UNITED STATES PATENT AND TRADEMARK OFFICE

APPLICATION NO.	FILING DATE	FIRST NAMED INVENTOR	ATTORNEY DOCKET NO.	CONFIRMATION NO.
10/711,640	09/29/2004	Basanth Jagannathan	FIS920040085	5639
45988	7590	04/03/2006	EXAMINER	
GREENBLUM & BERNSTEIN, P.L.C. 1950 ROLAND CLARKE PLACE RESTON, VA 20191				NGUYEN, TRAM HOANG
ART UNIT		PAPER NUMBER		
2818

Office Action Summary	Application No.	Applicant(s)	
	10/711,640	JAGANNATHAN ET AL.	
	Examiner	Art Unit	
	Tram H. Nguyen	2818

DETAILED ACTION

FIG.-1H

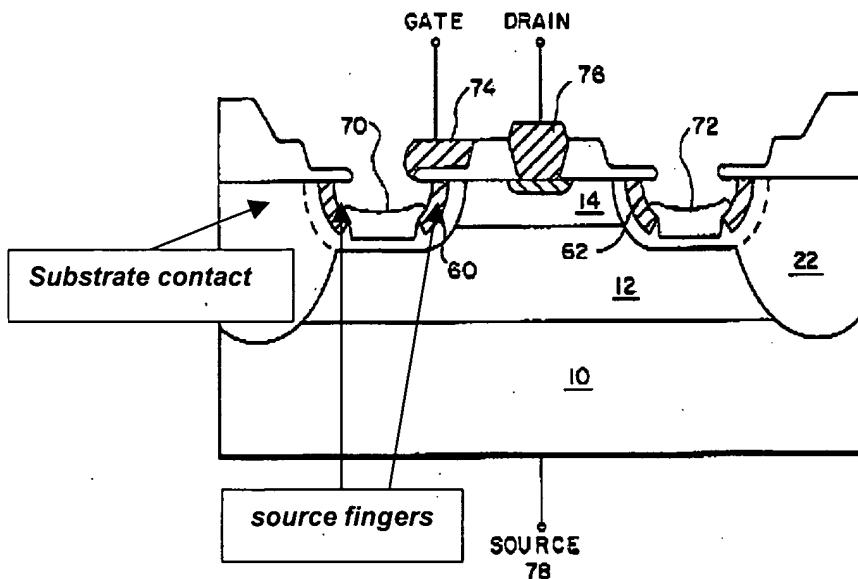
Regarding to **claim 18**, Herzum discloses all the limitation of the claimed invention for the same reasons are set-forth above except for not explicitly teach the source comprises a source finger and the substrate contact abuts substantially all of one side of the source finger. However, fig. 1H of Rice shows the substrate contact (reference numeral 20) abuts all of one side of the source finger (reference numeral 60) (col. 4, line 19). Therefore, it is considered obvious to one of ordinary skill in the art, at the time the invention was made, to provide a source direct source to substrate contact in order to reduce expensive packaging techniques (col.1, lines 56-59).

Regarding to **claim 19**, Herzum and Rice disclose all the limitations of the claimed invention for the same reasons are set-forth above; likewise, Rice also teaches two source fingers arranged within substrate, wherein the substrate contact abuts two of the two source fingers (refer the above fig. 1H).
